Section 4.55(2) Modification Application to DA35/2024

1 Gatacre and 1-5 Allison Avenues, Lane
Cove

APRIL 2025

Figure 32. Proposed Development Visual Impact Study
Source: PBD Architects

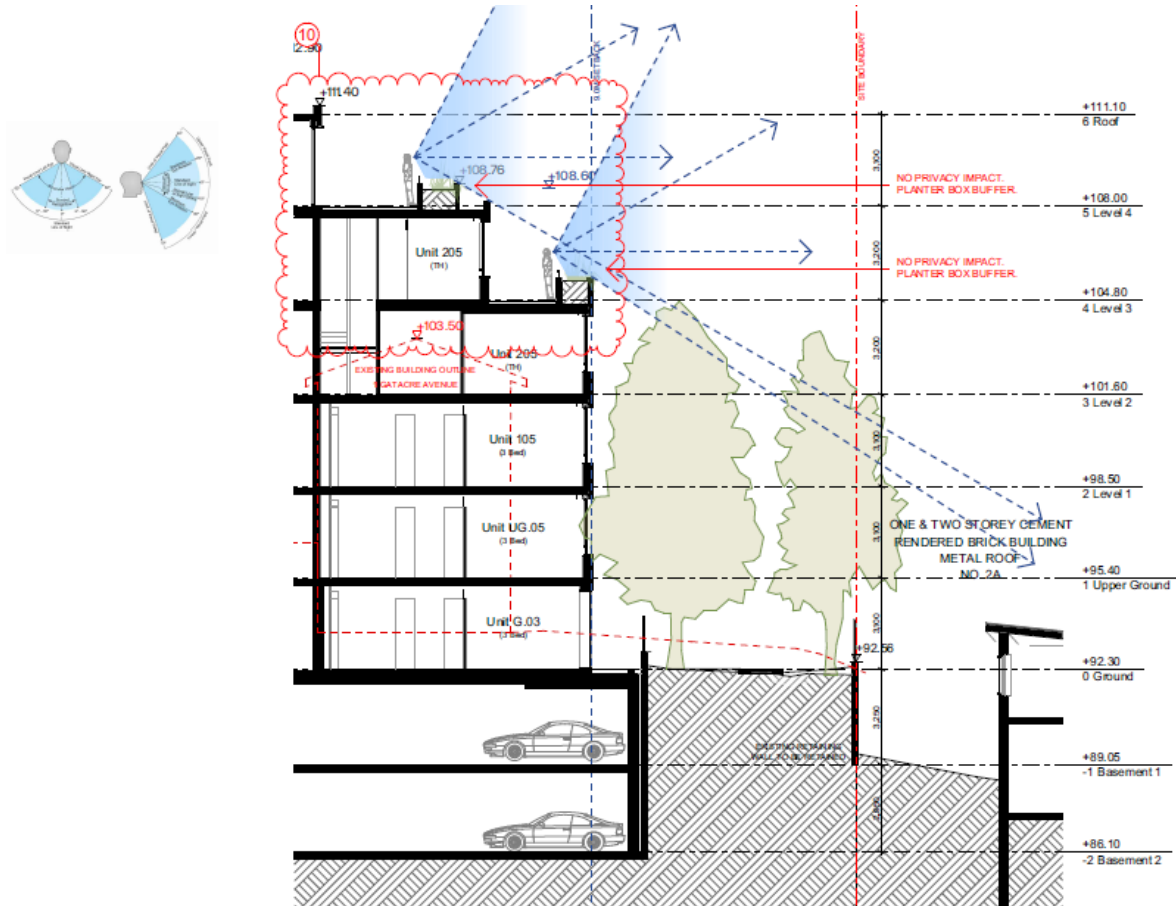
The proposed conversion of previously non trafficable terraces into a private open space for units 205, 302, 401, and 402 will not result in additional impact on neighbouring properties visual privacy, as per Figure 32 due to the landscaped buffer provided by the approved planter boxes. Similarly, the proposed modifications to the wording of Condition 2 will not result in any additional privacy concerns as demonstrated in Figure 26 and Figure 27.

Figure 33. Proposed Overshadowing to 7 Allison Avenue
Source: PBD Architects

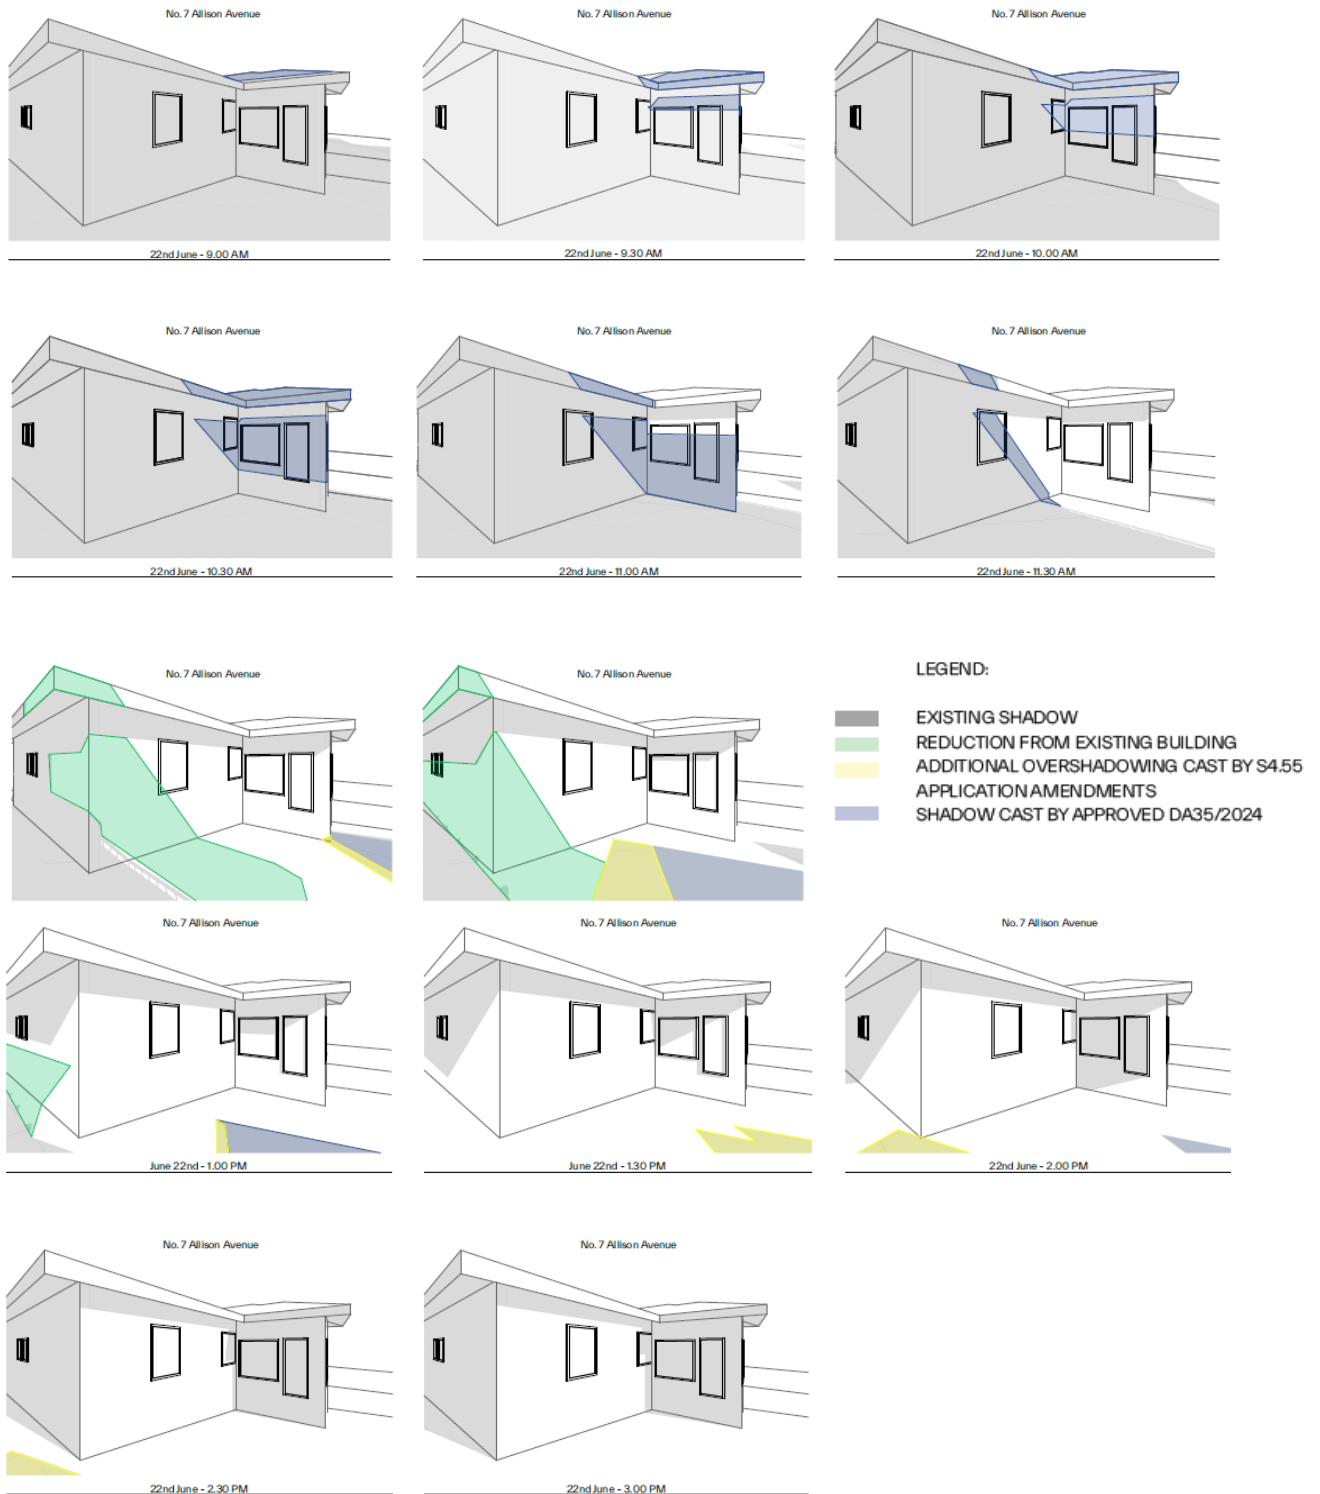
The proposed modification will technically result in minor additional overshadowing to the rear private open space for 7 Allison Avenue, as per Figure 33. However, it is important to consider the actual site conditions, which are heavily vegetated. When the existing and proposed landscaping are incorporated into the overshadowing model, there is no additional overshadowing experienced beyond what was approved under **DA35/2024** as per Figure 34.
